# Access Compliance Report

## Public Rights-of-Way

Intersection ID: 18800	Main Street: PARK_RD	Cross Street: SENECA_PL	Location: SW
ADA ID: C7E49C08AAA4	Ramp Type: BlendTrans2	Initial Pass/Fail: Fail	Overall Compliance: No
		Severity Score: 60

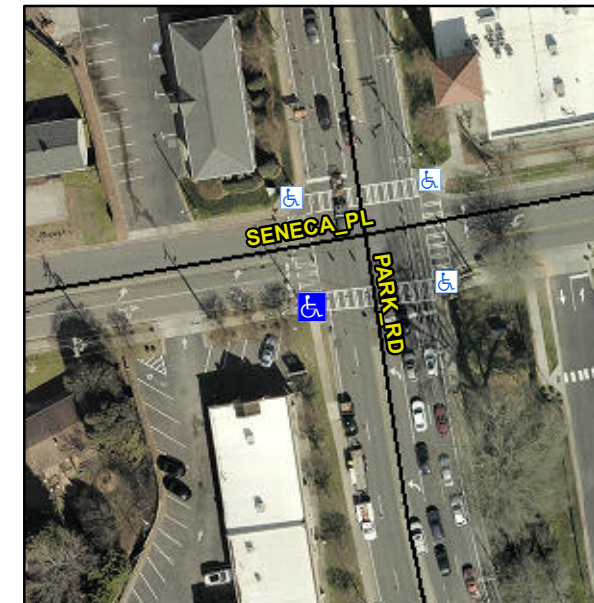
**R304.5.1, R304.5.3**

Compliance	Description	Data	Compliance	Description	Data
N/A	Ramp Length (in)	102.0	Yes	BlendTrans Slope (%)	2.7
No	Ramp Width (in)	30.0	No	BlendTrans XSlope (%)	8.7
N/A	Flare Type LT	N/A	N/A	Flare Type RT	N/A
N/A	Flare Slope LT (%)	N/A	N/A	Flare Slope RT (%)	N/A
N/A	Flare Traversable LT?	N/A	N/A	Flare Traversable RT?	N/A
N/A	Landing Length (in)	N/A	N/A	DWS Provided?	N/A
N/A	Landing Width (in)	N/A	N/A	DWS Contrast?	N/A
N/A	Landing Slope (%)	N/A	N/A	DWS Length (in)	N/A
N/A	Landing X Slope (%)	N/A	N/A	DWS Full Width?	N/A
N/A	Landing Curb? (Y/N)	N/A	N/A	DWS Offset (in)	N/A
N/A	Shared Landing?	N/A			
N/A	Gutter Ponding?	N/A	N/A	Gutter Slope (%)	N/A
N/A	Gutter Lip Ht (in)	N/A	N/A	Gutter X Slope (%)	N/A
N/A	Painted X Walk1?	Yes	N/A	Painted X Walk2?	Yes
	X Walk 1 Direction	To E		X Walk 2 Direction	To N
	X Walk 1 Width (in)	120.0		X Walk 2 Width (in)	115.0
	X Walk 1 Slope (%)	1.3		X Walk 2 Slope (%)	3.8
	X Walk 1 X Slope (%)	4.9		X Walk 2 X Slope (%)	2.7

**Remove & Replace Curb Ramp With Two New Directional Ramps or Equivalent.**
